TECHNICAL SPECIFICATION CHANGE REQUEST NO. 103

TITLE: SECTION 6: ADMINISTRATIVE CONTROLS

FIGURE 6.2-1
CORPORATE ORGANIZATION

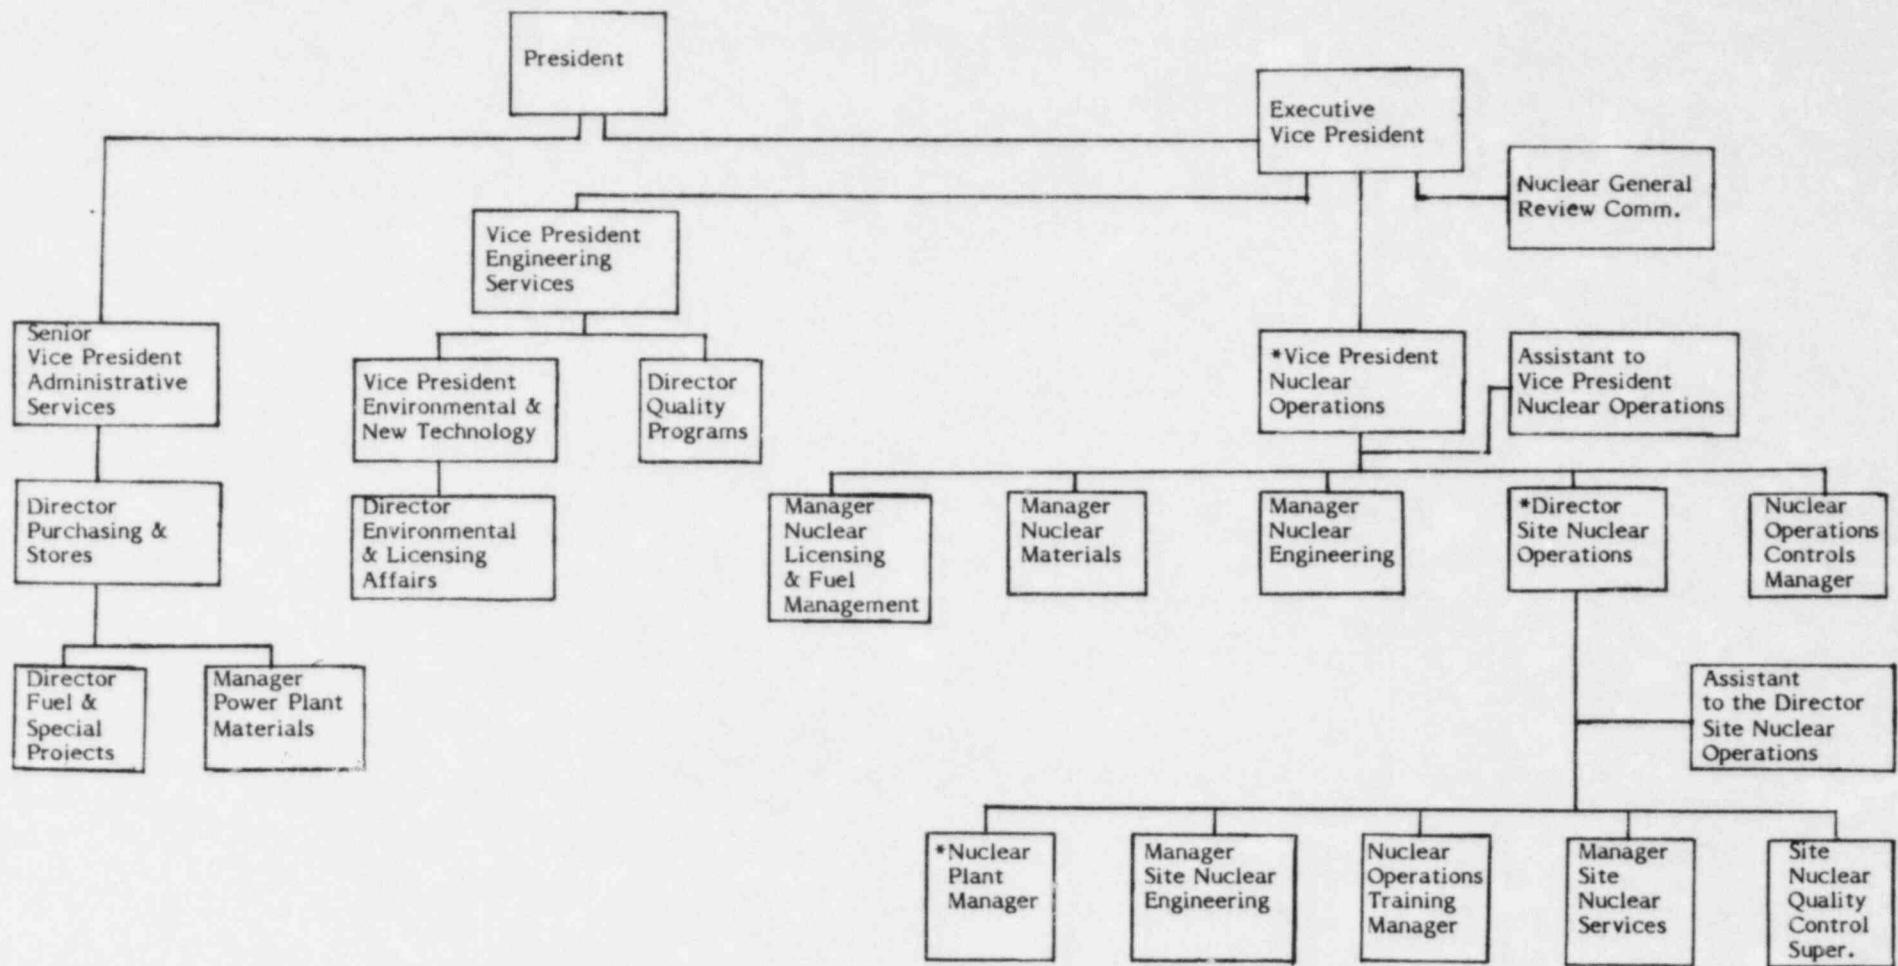
- 1) On page 6-2: Change Figure 6.2-1 to indicate the present corporate organizational structure.
- 2) On page 6-3: Revise Figure 6.2-2 to show the general responsibilities of each department rather than every position in each department.

The new Figures 6.2-1, Corporate Organization, and 6.2-2, Facility Organization, will update T.S. 6.2.1 and T.S. 6.2.2 to agree with the present organization. Moreover, listing departmental responsibilities on Fig. 6.2-2, rather than the positions within each department, will help clarify the responsibilities of each group and interdepartmental relationships. This may also reduce the frequency of changing this organization chart.
